Architectural Review Board Staff Report

Project Type:	Amended Architectural Elevations
Meeting Date:	November 09, 2023
From:	Shilpi Bharti, Planner 
Location:	900 Spirit of St. Louis.
Description:	Gateway Studios, Lot 1A: Amended Architectural Elevations and Architect's Statement of Design for a 19.3-acre tract of land zoned "PC" Planned Commercial District located on the north side of Chesterfield Airport Road and east of Spirit of St. Louis Boulevard.

Arco Construction on behalf of Gateway Studios, LLC has submitted Amended Architectural Elevations for the recently approved Gateway Studio buildings. The elevations are amended to include screening walls for roof top mechanical equipment on all four sides of the building and replace some portion of the curtain wall on the south and west elevation.

Figure 3: Replaced Curtain wall on west

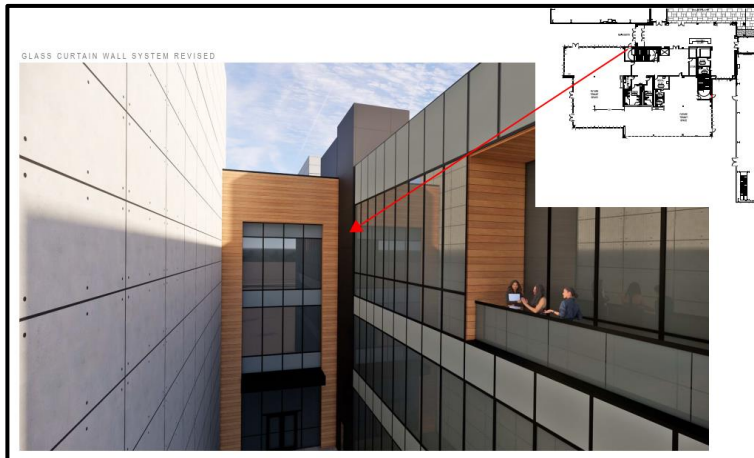
The Studio and the Office building of Gateway Studios is under construction. Applicant has submitted Amended Architectural Elevations to include the roof top mechanical equipment screening wall on the building. The tallest screening will be 17’ high that will be visible from west and north side of the building. Additionally, the proposed curtain walls on the west and south interior walls will be replaced by ACM paneling which is similar to the roof deck area as shown in figure 3 and 4.

GATEWAY STUDIOS | REVISED RENDERINGS

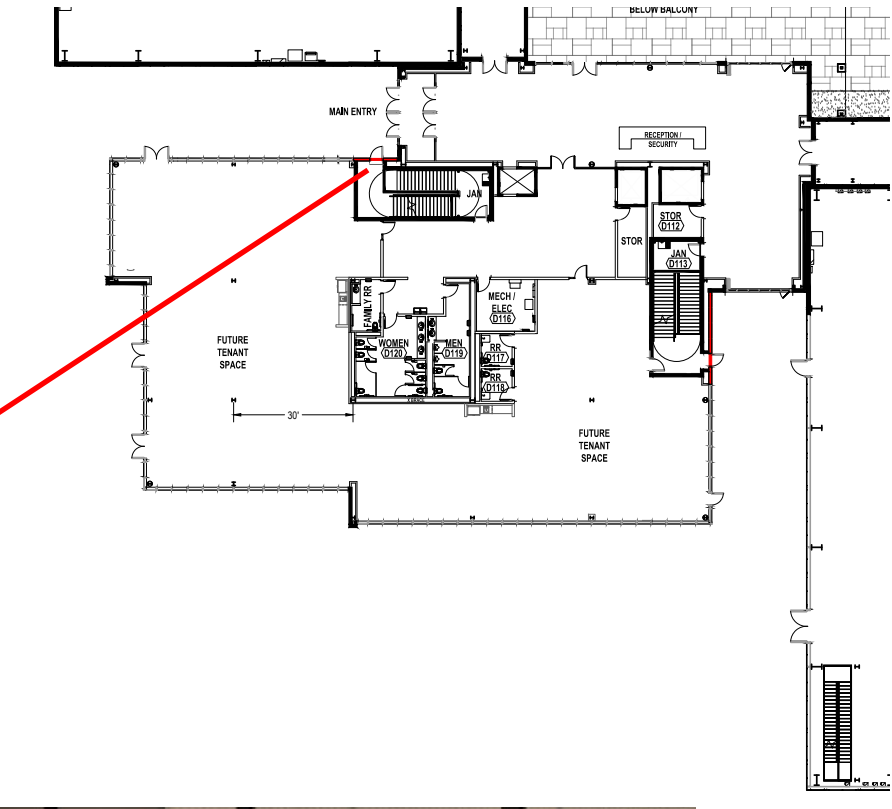
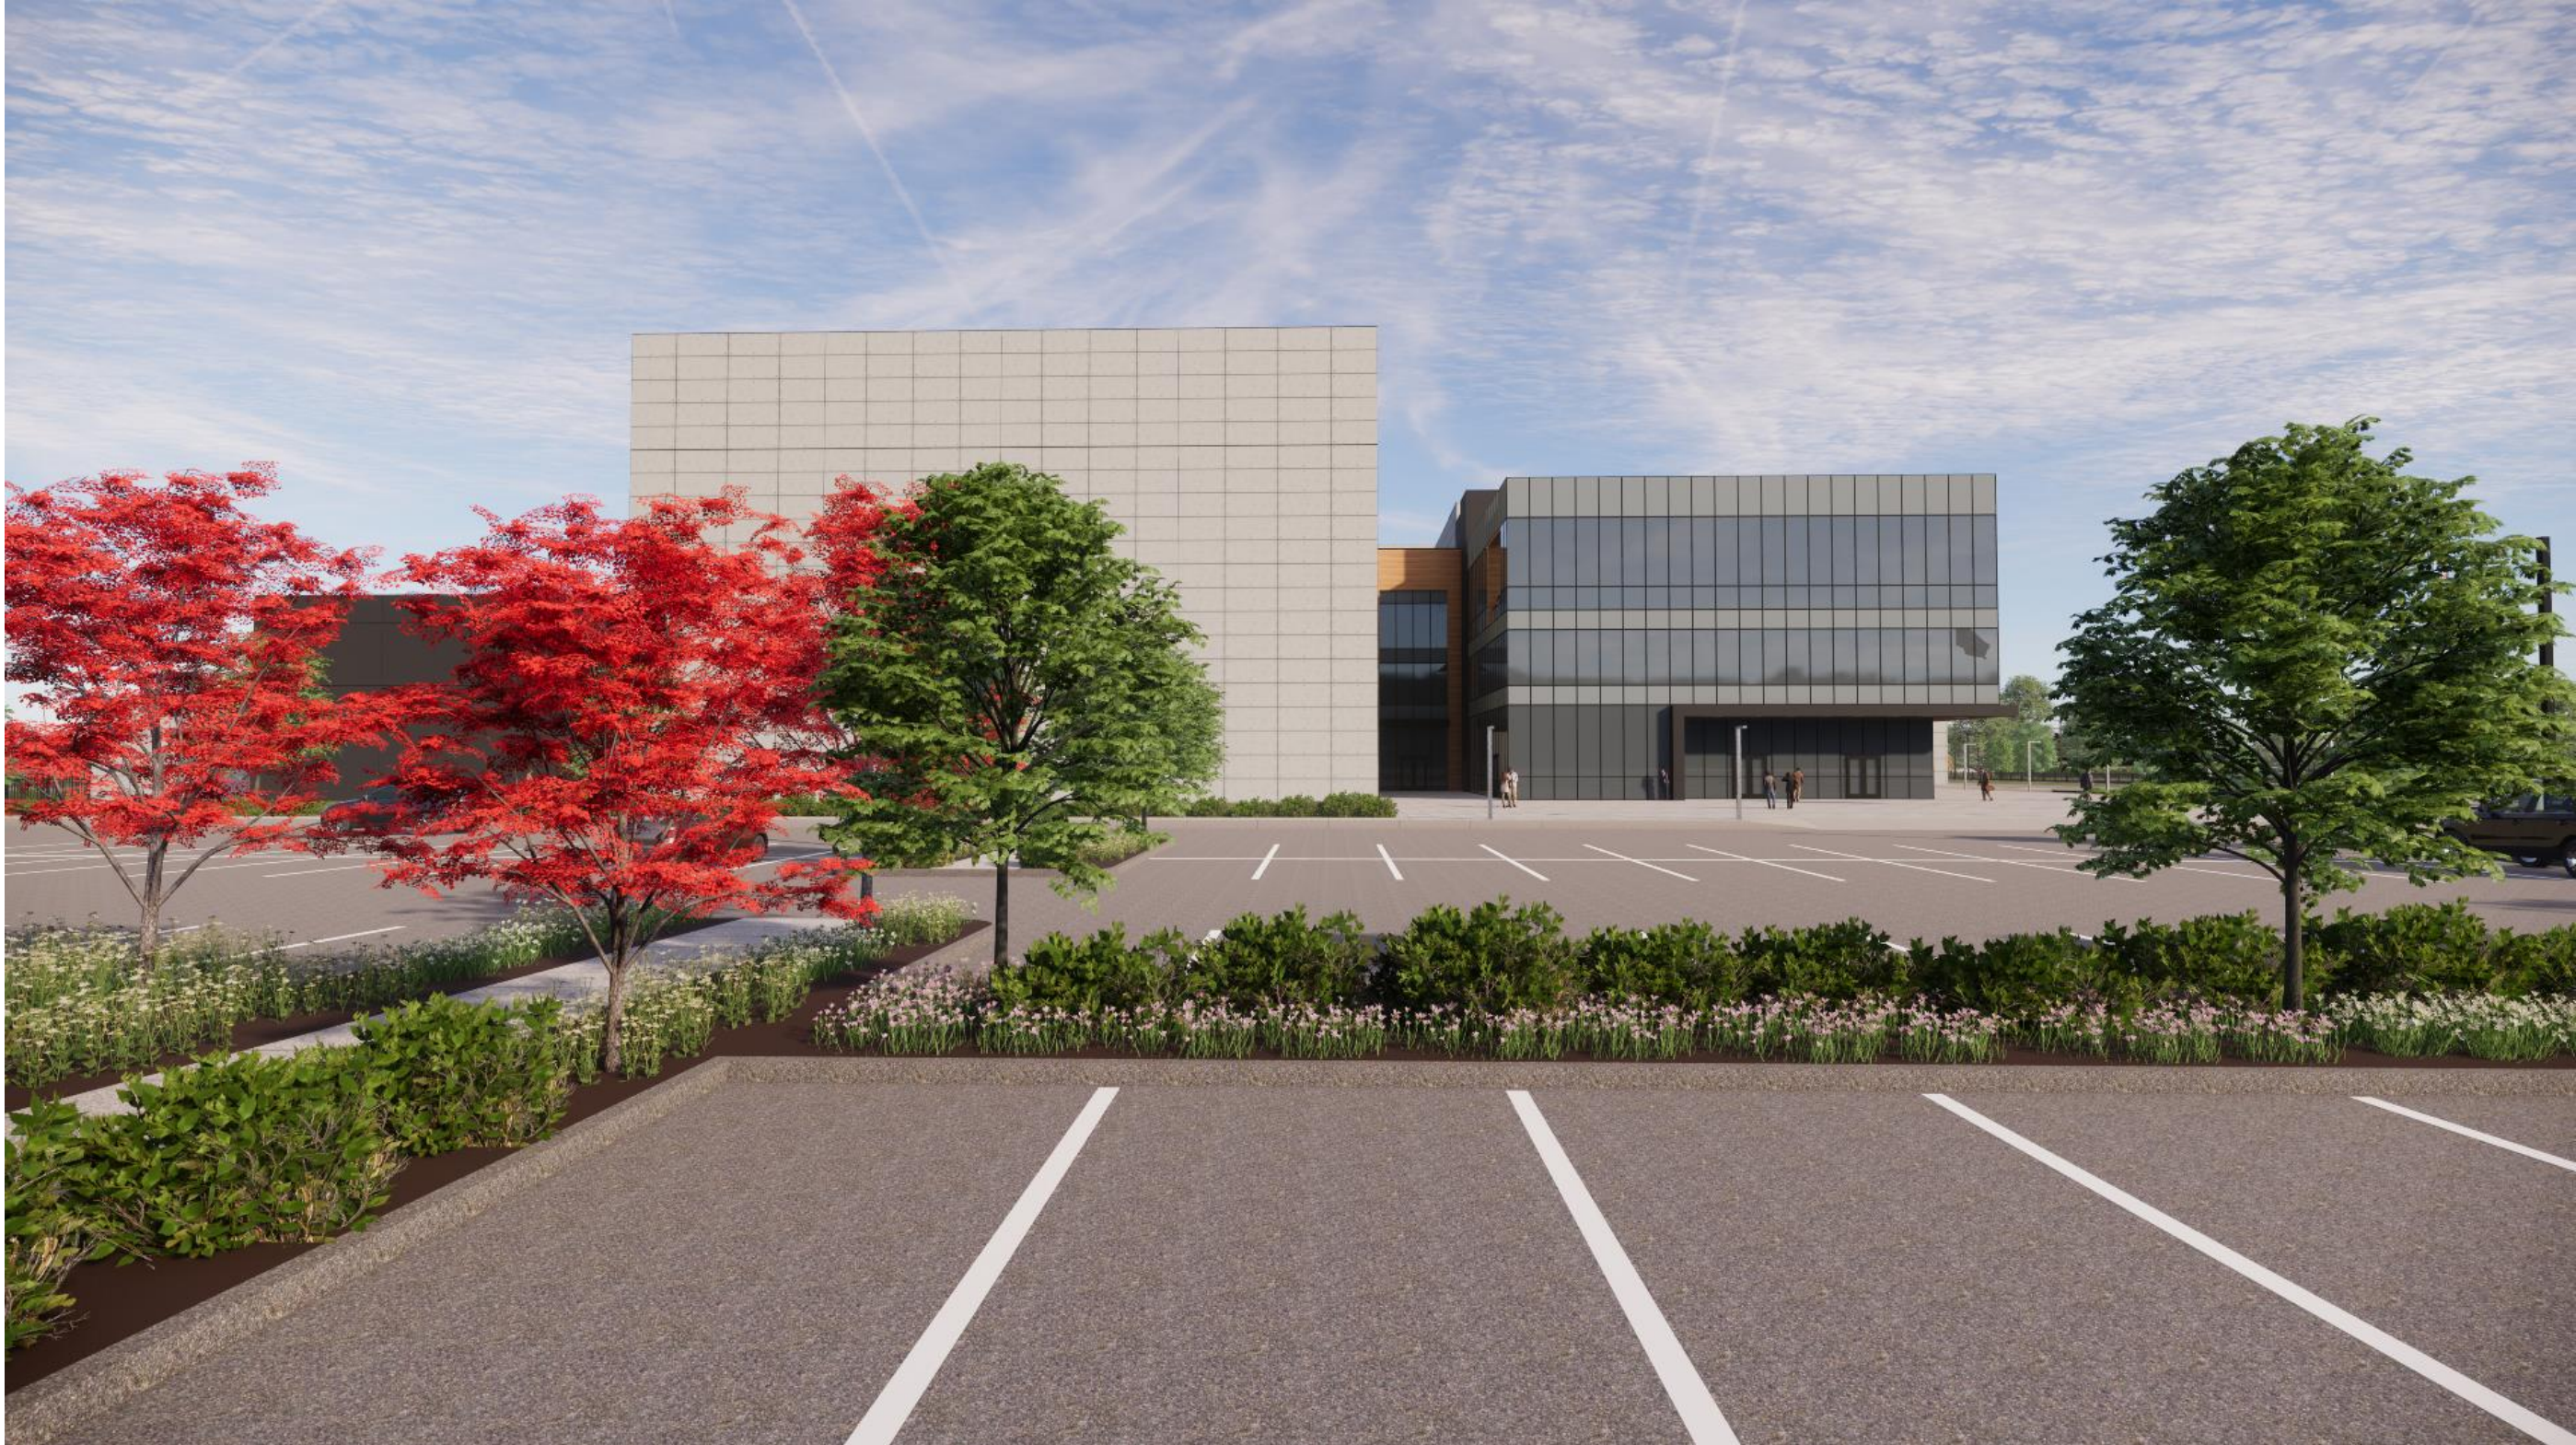
GLASS CURTAIN WALL SYSTEM REVISED

GLASS CURTAIN WALL SYSTEM REVISED
